State of New York  
Department of Agriculture and Markets  
10B Airline Drive  
Albany, New York 12235

California Energy Commission  
Dockets Office, MS-4  
Re: Docket No. 07-HFS-01  
1516 Ninth Street  
Sacramento, CA 95814-5512

Comments on Fuel Delivery Temperature Study Final Draft  
By  
Ross J Andersen, Director of Weights and Measures

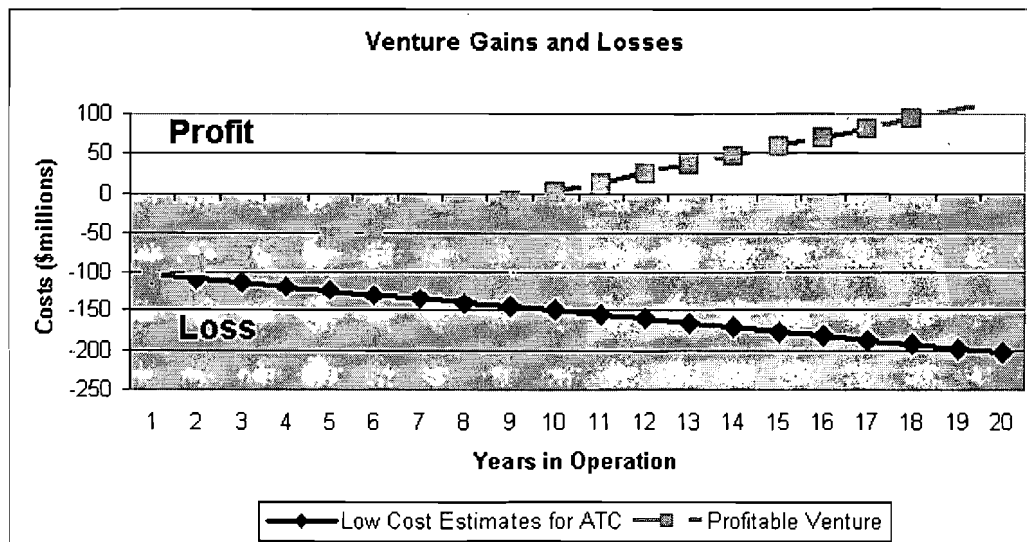
I and others have tried hard to ensure that the retailer's handling of temperature information in setting price is properly explored and understood. Without that, that reader is going to think the hot fuel fraud is possible. It is vital that it be clear how the retailer makes the conversion from net gallon units under which he bought his product and the gross gallon units under which he sells his product. I also note that virtually many retailers have to do this as the terms of wholesale transactions are often in different units of measure than actually used by the retailer in dealing with their customers. For example, a retailer may buy by the gross (12 dozen or 144 count) and yet sell by dozen or by each. To evaluate his costs he is forced to make a units conversion. I provided this kind of analysis in my presentation to the Commission as did both of the economists that commented at the hearing today.

Another important fact is that the cost of goods sold is not handed to the retailer. I've never seen it in \$/gal units on an invoice and I've seen quite a few. Instead, each cost is itemized on the invoice. The retailer has to add his non-fuel costs to the total cost of the fuel purchase to calculate his target selling price as a function of total costs for inventory received divided by units taken in to inventory and available for sale. I find the report clearly explains the impact of temperature on the fuel and the effects of fuel density but find little or nothing about the competitive forces that drive the sales price to compensate for these variables when selling on a gross basis.

I supplied analysis of this units conversion and so did the other economists that testified at the workshop. I liked the analysis that included the markup to show that the cost of the fuel remained unchanged regardless of whether the fuel was sold on a net or gross basis. That analysis shows that a few degrees difference between delivery temperature to competing retailers does not really result in significantly different values for gross retail cost before markup, since pricing moves in whole cent increments.
